**Report: Deficiency Report**  
**Function: Test, Adjust, & Balance**  
**Date: 10/08/2025**  
**Completed By: National TAB**

**PROJECT**  
**10-06-25 QT #1121 EASLEY, SC**

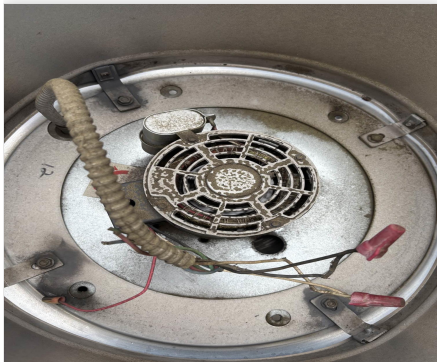
**Issue Name :** EF-1 not working  
**Description :** When attempting to turn on the fan the motor began to smoke.  
**Created By :** National TAB                      **Assigned To :** National TAB - Brianna Biggs  
**Status :** Open  
**Priority :** High                                      **Asset Tag :** EF1  
**Originated Date :** 10/08/2025 - Christian Moller - National TAB

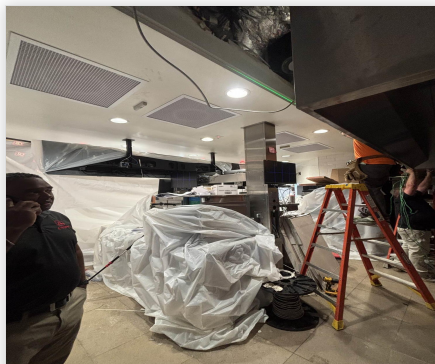
**Issue Name :** RTU 2 & 3 economizers don't work  
**Description :** RTU 2&3 economizers do not work. When using the dial on the economizer itself as well as the Emerson board the flaps do not open.  
**Created By :** National TAB                      **Assigned To :** National TAB - Brianna Biggs  
**Status :** Open  
**Priority :** High                                      **Asset Tag :**  
**Originated Date :** 10/08/2025 - Christian Moller - National TAB
